NOTICE TO MARINERS

SEPTEMBER 2021

Karta Piranski zaliv 02 (WGS84)

Karta Tržaški zaliv 03 (WGS84)

Blok za karto Piranski zaliv 02
Block for Chart Piranski zaliv 02

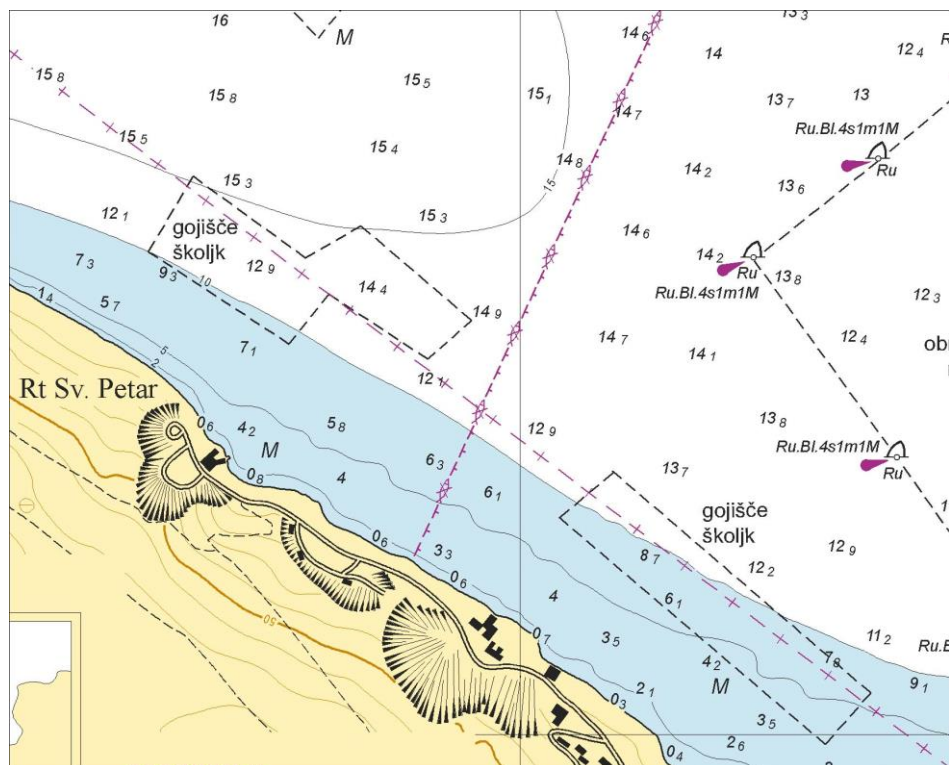
Vstaviti spremljajoči blok, s središčem v: 45° 29'·4N., 013° 33'·9E.

Insert the accompanying block, centred on: 45° 29'·4N., 013° 33'·9E.
